**WEST SHORE LAKE PONTCHARTRAIN
HURRICANE AND STORM DAMAGE RISK REDUCTION STUDY
FINAL INTEGRATED FEASIBILITY REPORT
AND
ENVIRONMENTAL IMPACT STATEMENT**

**VALUE ENGINEERING
APPENDIX G**

VALUE ENGINEERING REPORT:

CEMVN-VE-14-02

TRADITIONAL PUMP STATION

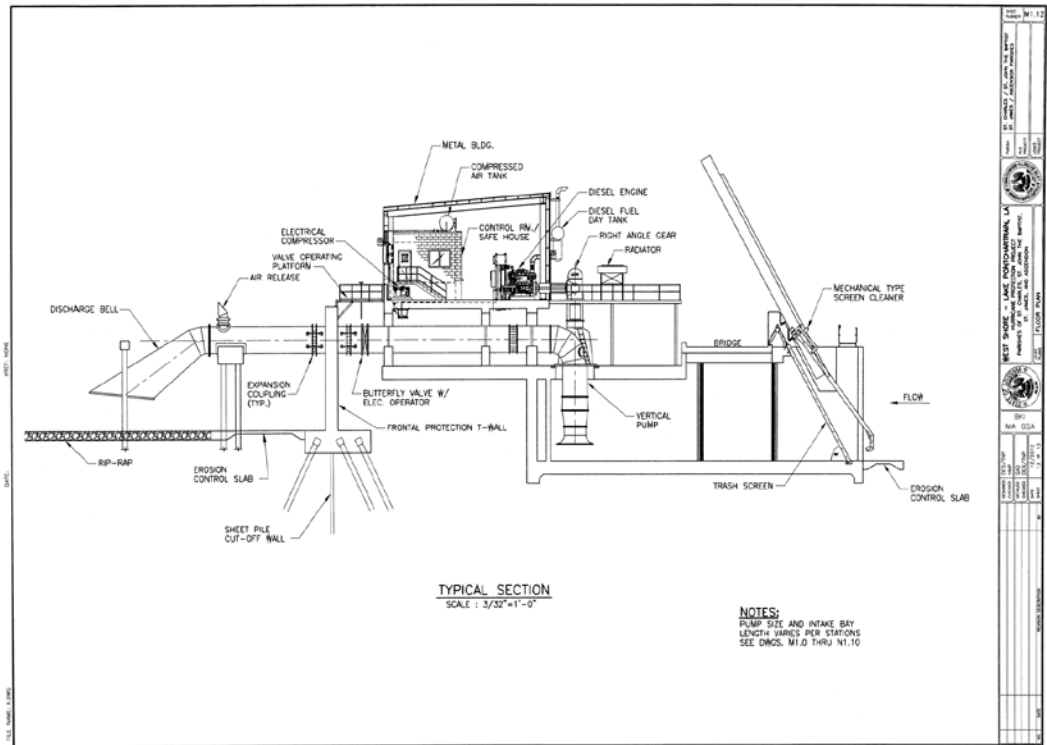
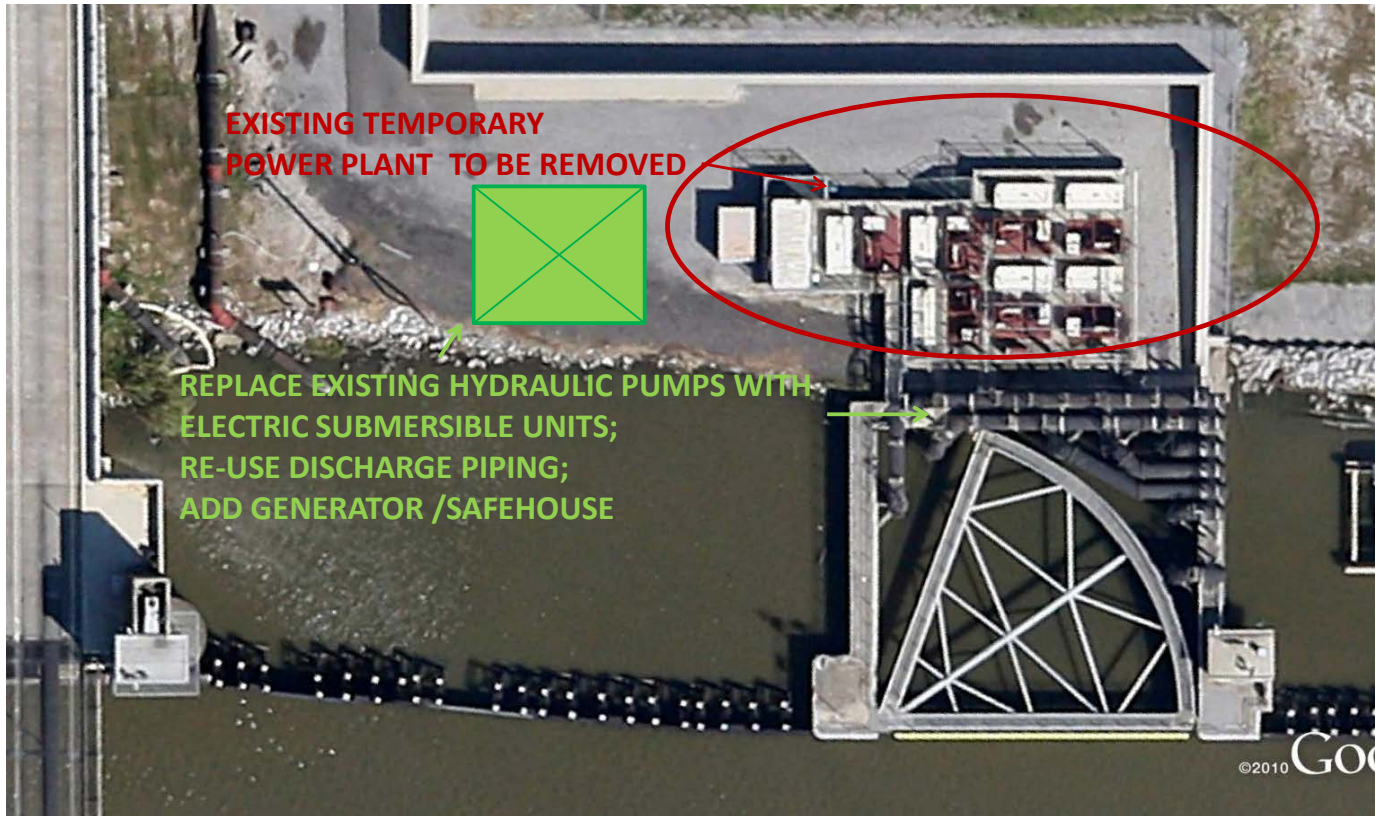
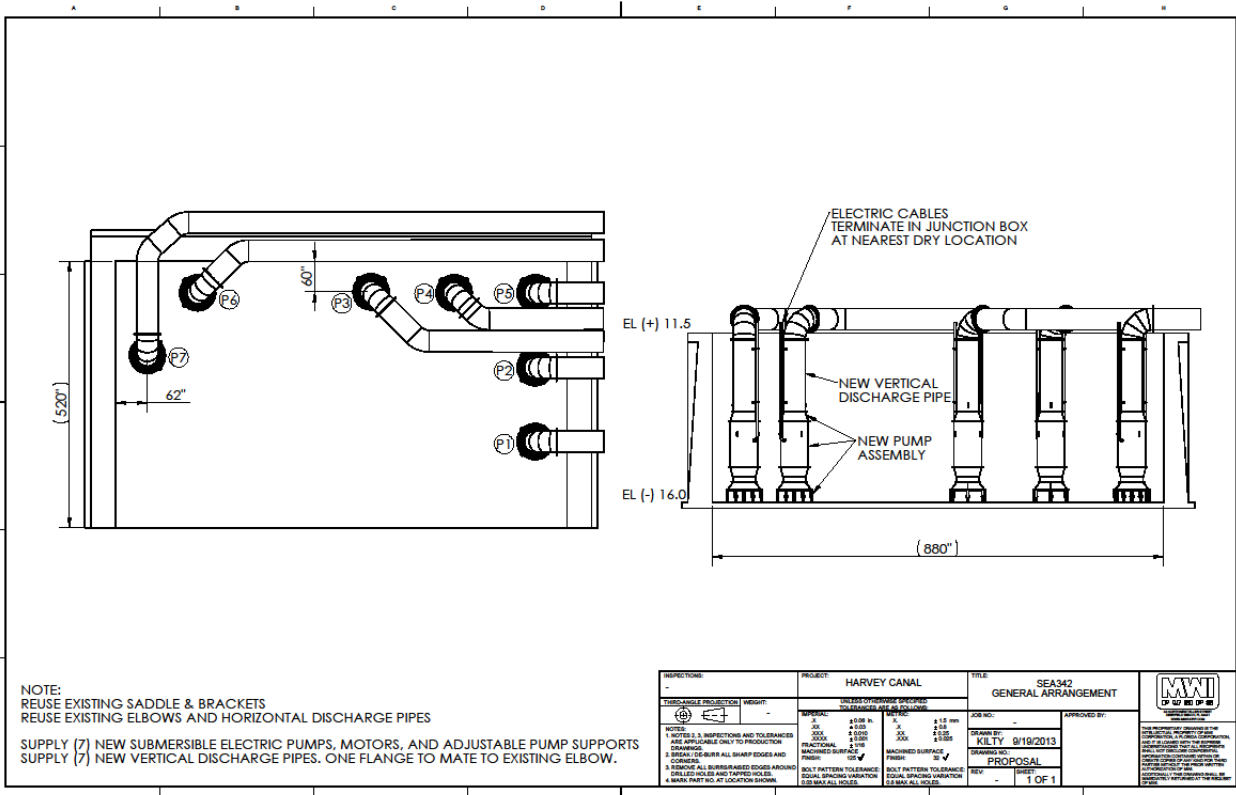
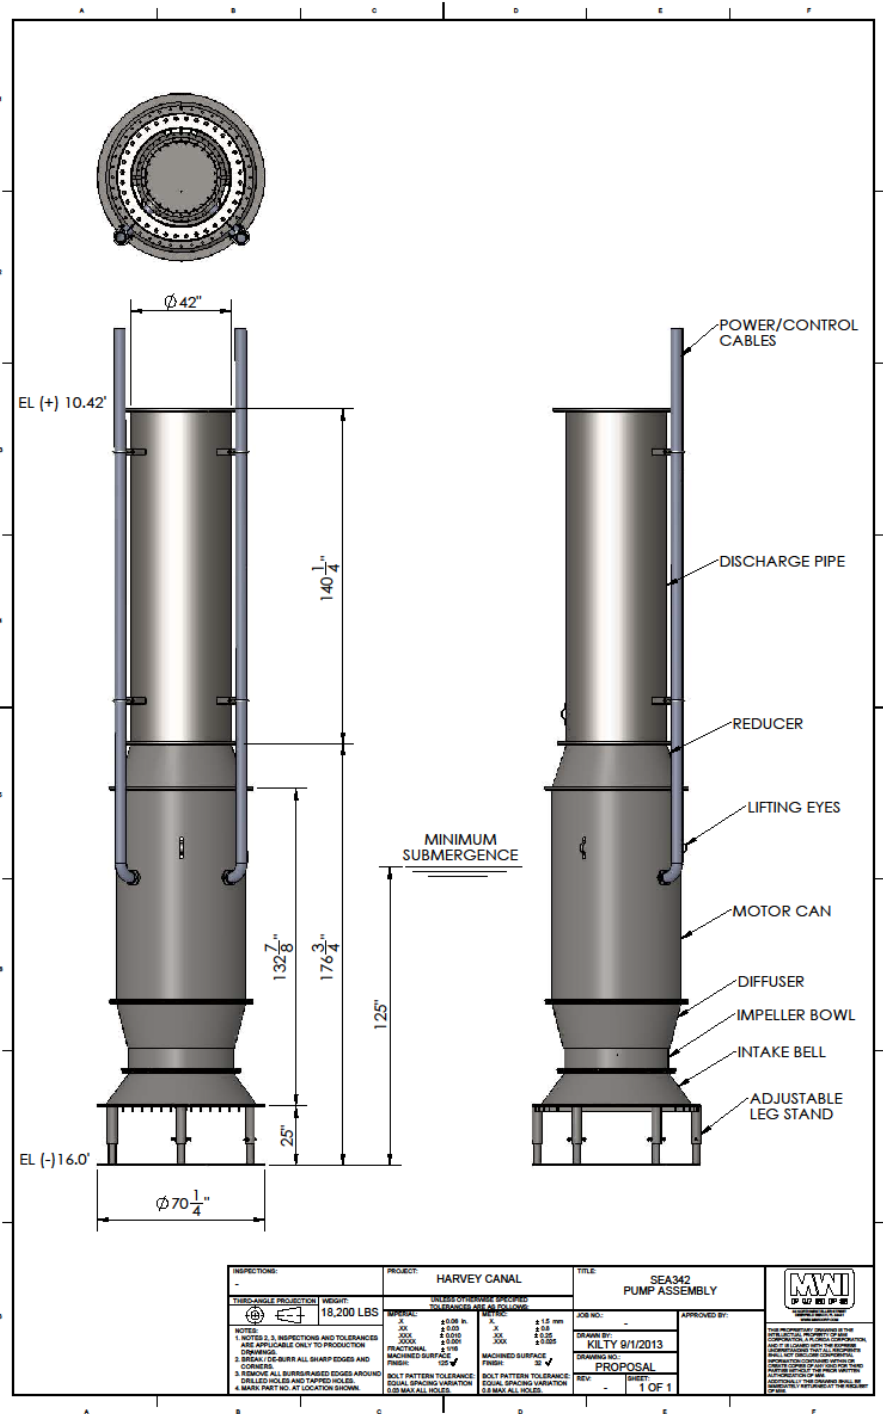
Item 7 – Consider optimized pump station design - A number of new pump stations are proposed for this project. Preliminary design indicates ‘traditional ‘type facilities for this range of station capacity (see below preliminary design sketch). Major features include, but are not limited to the following:

- vertical pumps with direct diesel drive
- siphonic discharge
- climber intake screen cleaning mechanism
- closed interior station with a operator ‘safehouse’ contained in the station building
- internal permanent lifting crane

In addition to considerations of proper station capacity and unit redundancy discussed in the above recommendation, ‘lessons learned’ from recent District, other Corps and local projects offer a number of possible options that could significantly improve design cost-effectiveness. Items that should be fully evaluated are:

Vertical pumps are generally cost-effective in most drainage applications. However, for stations in the capacity ranges designated in this project, other options are possible and may indirectly allow changes in total station configuration that could save significant cost. One option is electric submersible units powered by separate generators. Use of this type of pump offers much flexibility in the overall station structural design and can easily be automated (see comments below). This type of station has been recently constructed at Oakdale (see below photo) and is under consideration for permanent pumps at the Harvey Canal Sector Gates – 770 CFS (see design sketches below).

Given that these stations will not operate many hours power supply and energy savings afforded by lower operating head achieved via siphonic discharge do not warrant the cost of the discharge tubes. **It is important to note that these pumps must perform under near zero head conditions (gates closed tidal surge not yet arrived) as well as full flood elevation water levels.** As such, this would likely result in the need for induced head under normal tide levels via a ‘saxophone’ type (end turned upwards) discharge tube. This further increases the cost of the discharge tubes as well as reduces some of the desired power/energy recovery. Over top of wall open discharge requires a slight increase in driver power and very small added energy use but greatly simplifies the pumping system and first cost. This design concept has been successfully used for the East Ascension, Oakville and West Closure Complex pump stations.

Current local standards call for intake screen cleaning units to be fully operable under hurricane (wind conditions >120 mph) conditions. There appears to be very limited available units that can meet this requirement and is almost a sole-source condition. Units are very expensive relative to those that cannot achieve this criterion. Others in hurricane areas do not adhere to this standard and offer that it may not be practical or safe given that screen cleaning operation in very high wind conditions would either result in debris blowing right back into the intake or launched into the station structure. To address possible screen clogging during hurricane events, separated screen bridges are designed slightly wider. The possibility of Individual pump screens clogging is addressed in overall unit redundancy per discussed above. Cleaning mechanisms should, however, be designed to release debris away from the screen such that front-loader removal is not necessary to after the storm event.

Current local preference is to completely house all equipment and operation control in one large building. Post Katrina criteria also require an operator 'safehouse' capable of withstanding extreme hurricane conditions. Regardless of station size such a large containment structure is not necessary. Pump drivers and ancillary equipment can be protected via 'shell' covers with an independent qualified safehouse control room. Lifting crane(s) can either be brought in as needed or by external on an open frame or gantry track (see item below). A good example of such station configuration is the East Ascension Parish Pump Station. While the control room was not built to safehouse standards, the rest of the station utilizes such a shell cover concept (see below photo). *Also note that his station includes gravity gates integrated in the pump station structure (between each pump).*

Current local preference is to have a crane, capable of lifting the largest piece of equipment, permanently installed inside the single station building. This requires that the building have excessive height (and cost) to both house and support the crane. Since lifting a pump must be a planned event, it is possible to bring in a locally owned or rented crane for each event. A more favorable option is to have an external crane on a frame and/or gantry track in conjunction with a removable cover shell or low-rise building (roof panel).

Safehouses may be expensive, particularly if elevated above levee breach event water level. Also, manning each pump station in an event is not desired if a reliable alternative exists. It is proposed that perhaps only one or two stations be manned and have SCADA monitoring of the

other facilities. The un-manned stations could be auto-control by a fairly simple and reliable float switch system. This becomes a more viable option in conjunction with alternative pump type and discharge options discussed above.

All of the above considerations may be integrated into a comprehensive cost-effective design. It is recommended that the above mentioned local pump stations utilizing these alternative concepts as well as other stations with similar function such as Jacksonville District / South Florida Water Management District.
